## Planning Committee Meeting

**Wednesday, 14th December 2022**

4.1	Town Planning Application Decisions - November 2022 .....	5
4.2	KP-2015/336/C - Mentone Girls Grammar School.....	21
4.3	KP-2021/832 - Railway Reserve, Balcombe Road, Mentone (Lots 1 and 2 on TP597980P) .....	111
4.4	KP-2016/465/A - Moorabbin Reserve, 32-60 Linton Street Moorabbin .....	181
4.5	1233 Nepean Highway, Highett KP-2016/124/B S87A amendment ..	205

**Figure 15 - Concept plan showing the two (2) proposed bicycle hoops and a cross to indicate approximate location of existing bicycle hoops.**

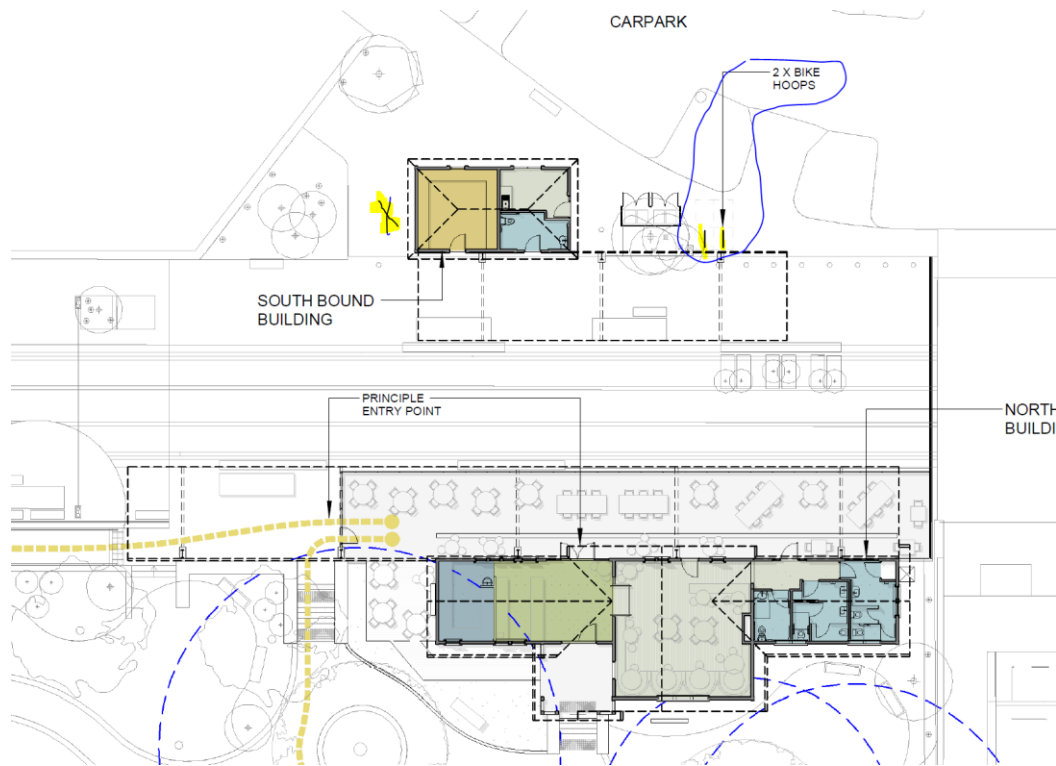
- 11.14 Notwithstanding, the applicant responded to the objection and stated that the plans can be updated to include the existing four (4) bicycle hoops. A requirement (**condition 1a**) will be placed on any permit issued for the existing four (4) bicycle hoops to be shown on the plans.

- 11.15 The objector requested a nine (9) space bicycle rack to replace the existing four (4) bicycle hoops, however the proposal is well in excess of the requirements of Clause 52.34.
- 11.16 The objector also stated that the proposed two (2) bicycle spaces are not in an appropriate location as it would obstruct access to the heritage deck public open space. The proposed two (2) bicycle hoops take up approximately 1 metre in width and this is not deemed to be a significant obstruction to pedestrian movement.
- 11.17 Pursuant to the *Planning and Environment Act 1987* and Kingston Planning Scheme, the following concerns fall outside of the scope of planning considerations.
- The proposed use of public land for private purposes  
There are no town planning related concerns specifically with the leasing of public buildings to tenants.

Figure 6: area requiring swept path analysis

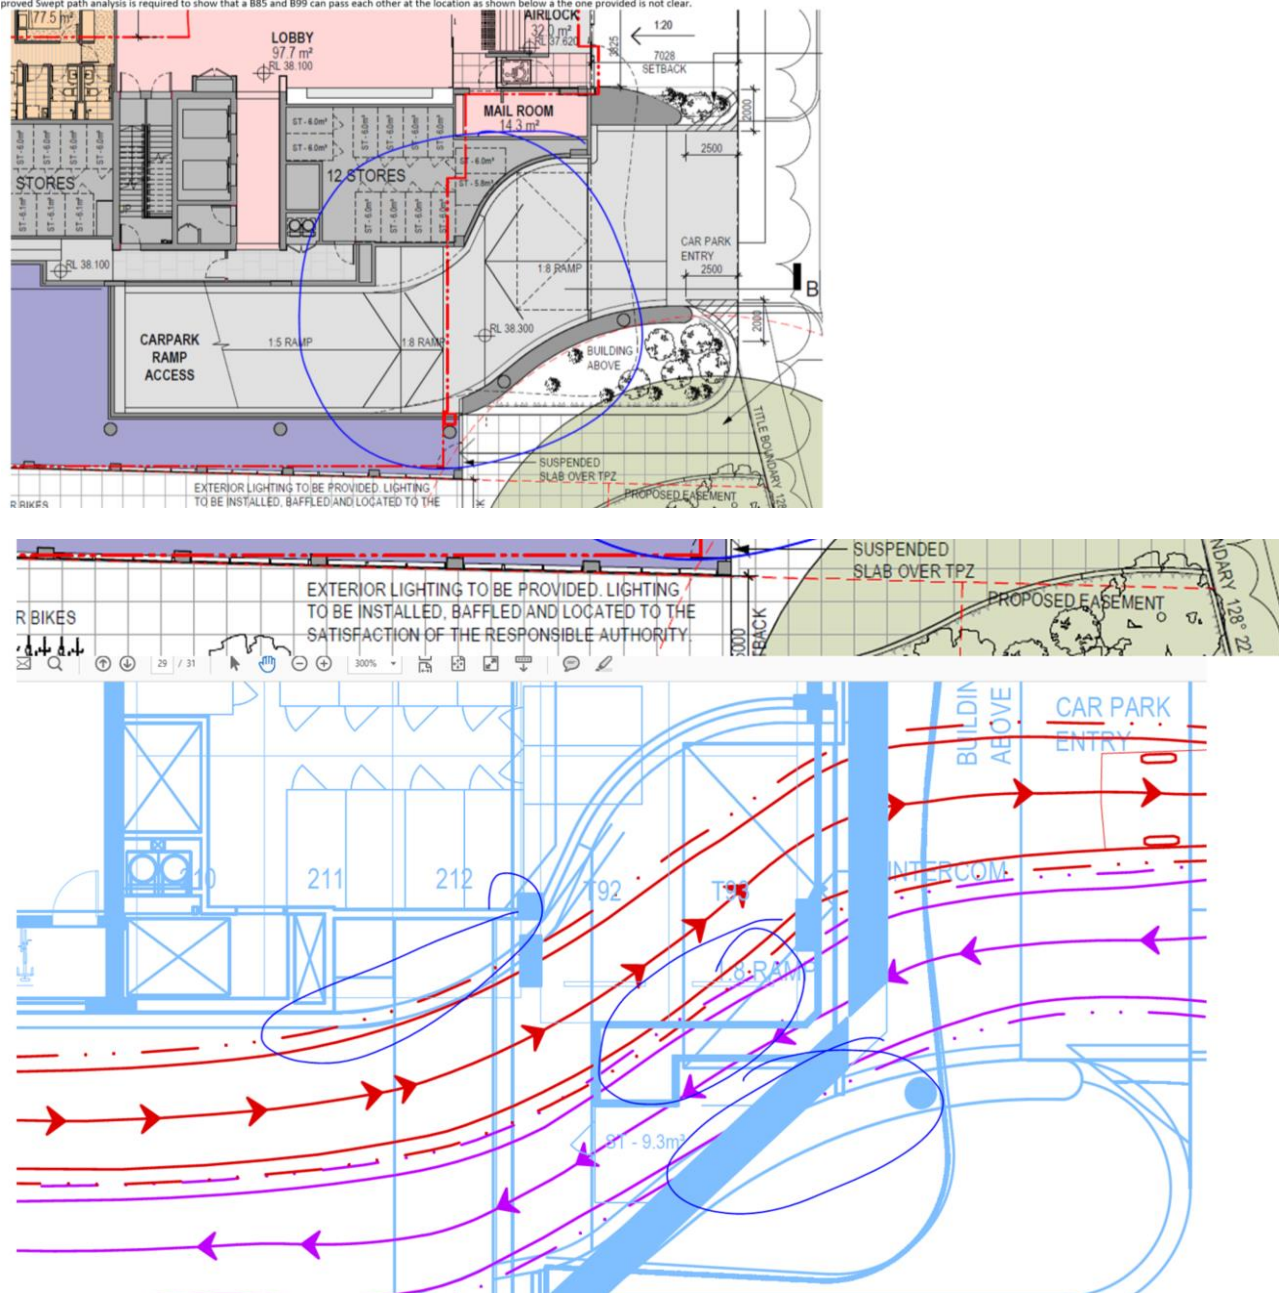
- *An improved swept path analysis is required to show that a B85 and B99 can pass each other at the location as shown below in Figure 6.*

proved Swept path analysis is required to show that a B85 and B99 can pass each other at the location as shown below a the one provided is not clear.

15. An improved swept path analysis is required to show that a B85 and B99 can pass each other at the location as shown in Figure 7 of the assessment.
16. Parallel parking spaces 28,29, 134, 136 need to be dimensioned and comply with Planning Scheme or AS/NZS 2890.1

Figure 7: Previous conditions as illustrated (lighting- blue circle) and loading bay (red circle) to be reinstated.

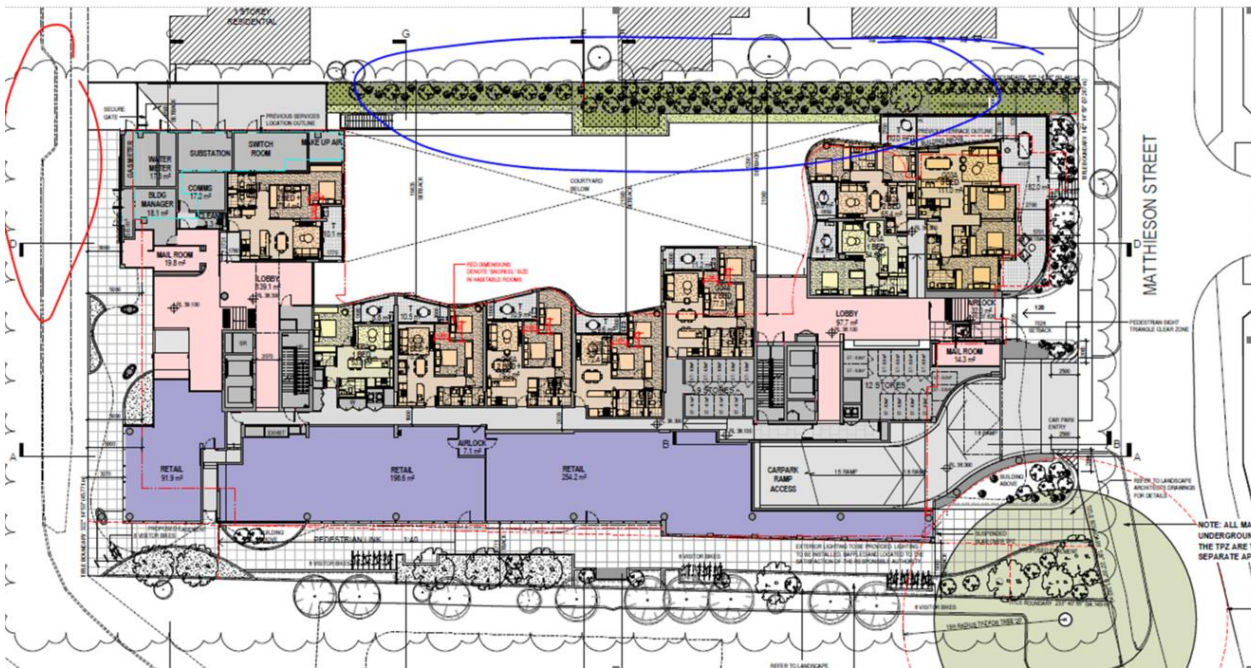
- Parallel parking spaces 28,29, 134, 136 need to be dimensioned and comply with Planning Scheme or AS/NZS 2890.1
- Space 193 and 88 needs 1m aisle extension otherwise swept path is required.
- 1m extension has to be provided for 170, 171, 65 and 66 as these spaces are designed based on 2890.1 and swept path shows they are difficult to access.
- All lighting (blue) and loading bay (red) creation on Nepean Highway as per previous conditions should continue (as illustrated in Figure 7).

19. All lighting (blue circle) and loading bay (red circle) creation on Nepean Highway as per previous conditions should continue (as illustrated in Figure 8).

Figure 11: Potential chamfering or curving of Nepean Highway corner (left) and area of concern towards Matthieson Street (right).

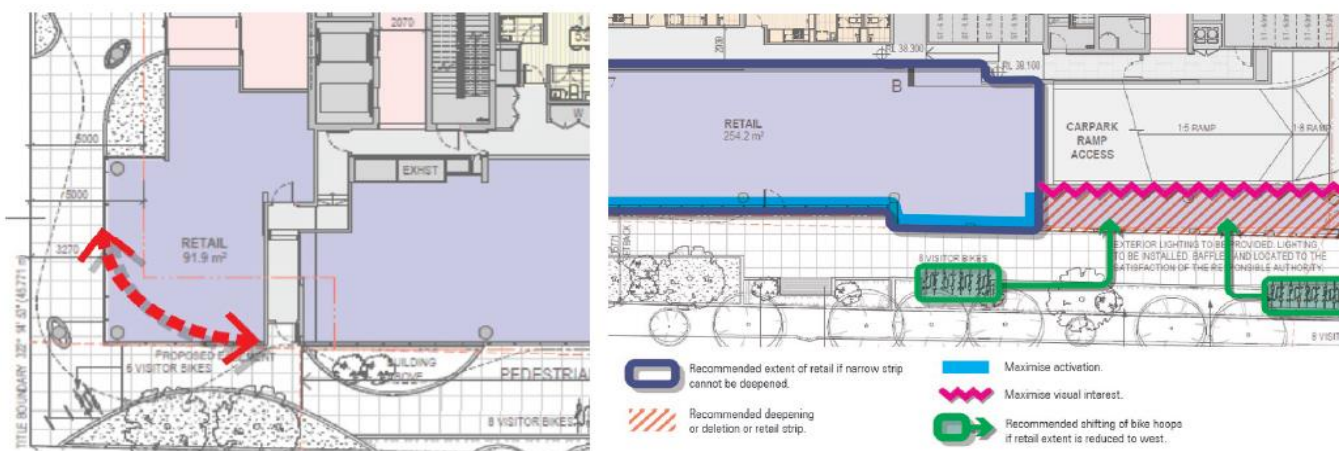
- 10.19 **Recommendations:** to further open up the laneway to Nepean Highway and maximise viability from the Nepean Highway, it is recommended that the applicant considers chamfering or curving the corner at ground level (and subsequently the void at upper ground level) as illustrated in Figure 11.

Figure 13: illustration of function issue of doors preventing access to rooms

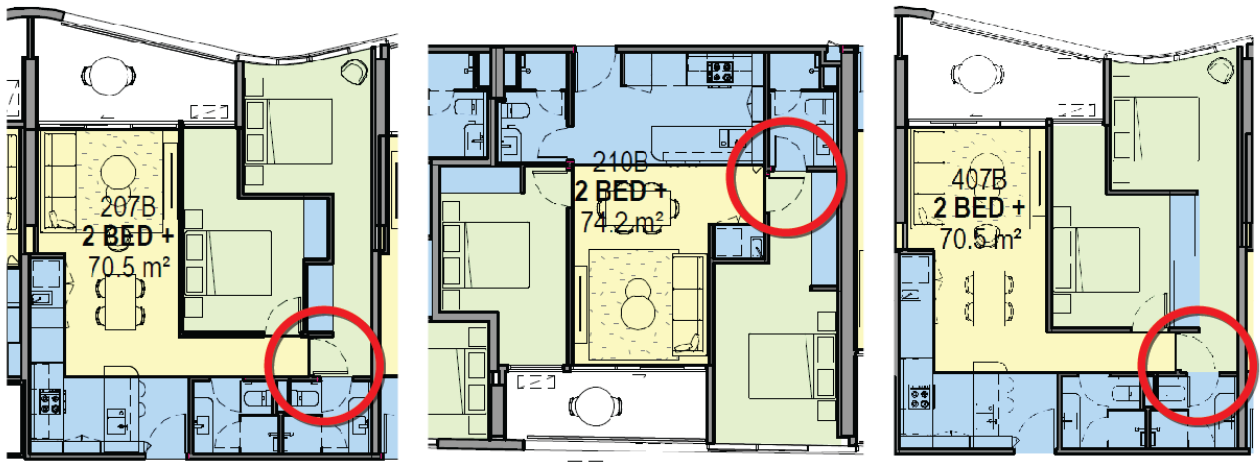
plans have not adopted the Tribunal recommendations that the minimum internal floor to ceiling heights in all habitable rooms should be 2.7m – which vary from 2.4m-2.7m. Bedrooms and living rooms are generally a minimum 2.5m in height, with 2.4m applied to kitchen, bathroom, laundry and storage areas. As habitable rooms are typically well within 9m of glazing, we consider the distribution of height to be broadly acceptable. A functional issue that is repeated across several apartments is the positioning and swing of doors preventing access to rooms while one or both are open. (as illustrated below in Figure 13).

Figure 15: what is proposed (left) vs endorsed (right)

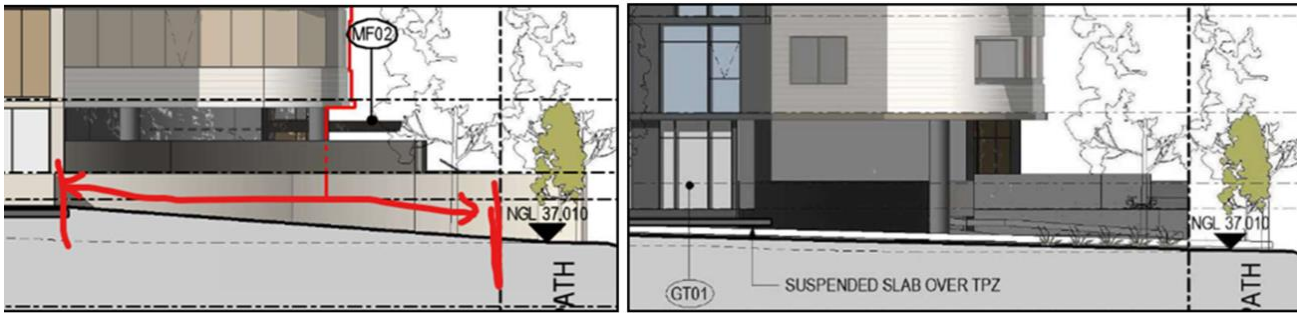
- 10.47 Furthermore, no support for the proposal in its current form is provided by Council's Vegetation Officer due to the level of encroachment into the TPZ of the River Red Gum. The proposed plans illustrate 100% encroachment of the Tree Protection Zone (TPZ) of the River Red Gum within the subject site. Encroachment should remain as what is currently shown and approved on endorsed plans including the endorsed arborist report and landscape plan. Figure 15 below illustrates the endorsed southern elevation on the right and the area highlighted by the red arrow the TPZ on the proposed plan. The image on the left illustrates a level change of an increase of approximately 1 metre, with the surface proposed to be paved. The comparison is that the endorsed plans manage the transition from NGL at the site boundary to the GFL via a boardwalk on raised piers as an increase in the depth of material over the exiting natural ground reduces oxygen available to the tree's root system. This is not proposed in the current plans before the Tribunal.
